Access Compliance Report

Public Rights-of-Way

Intersection ID: 26740	Main Street: SIMFIELD_CHURCH_RD	Cross Street: WEDDINGTON_RD	Location: NE
ADA ID: 7D816C583973	Ramp Type: Perp	Initial Pass/Fail: Fail	Overall Compliance: No
Severity Score: 21.25			
Codes/Mitigation Info/Possible Solution		Field Measurements/Component Compliance

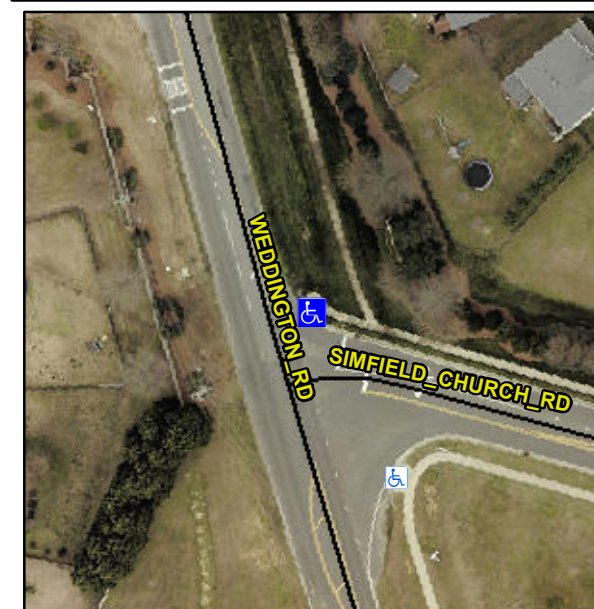
R304.5.1, R304.2.2

Compliance	Description	Data	Compliance	Description	Data
N/A	Ramp Length (in)	47.0	No	Ramp Slope (%)	10.3
No	Ramp Width (in)	40.5	Yes	Ramp XSlope (%)	2.0
N/A	Flare Type LT	N/A	N/A	Flare Type RT	N/A
N/A	Flare Slope LT (%)	N/A	N/A	Flare Slope RT (%)	N/A
N/A	Flare Traversable LT?	N/A	N/A	Flare Traversable RT?	N/A
N/A	Landing Length (in)	N/A	N/A	DWS Provided?	N/A
N/A	Landing Width (in)	N/A	N/A	DWS Contrast?	N/A
N/A	Landing Slope (%)	N/A	N/A	DWS Length (in)	N/A
N/A	Landing X Slope (%)	N/A	N/A	DWS Full Width?	N/A
N/A	Landing Curb? (Y/N)	N/A	N/A	DWS Offset (in)	N/A
N/A	Shared Landing?	N/A			
N/A	Gutter Ponding?	N/A	N/A	Gutter Slope (%)	N/A
N/A	Gutter Lip Ht (in)	N/A	N/A	Gutter X Slope (%)	N/A
N/A	Painted X Walk1?	No	N/A	Painted X Walk2?	N/A
	X Walk 1 Direction	To S		X Walk 2 Direction	N/A
N/A	X Walk 1 Width (in)	N/A	N/A	X Walk 2 Width (in)	N/A
	X Walk 1 Slope (%)	3.6		X Walk 2 Slope (%)	N/A
	X Walk 1 X Slope (%)	0.9		X Walk 2 X Slope (%)	N/A

Remove & Replace Entire Ramp.
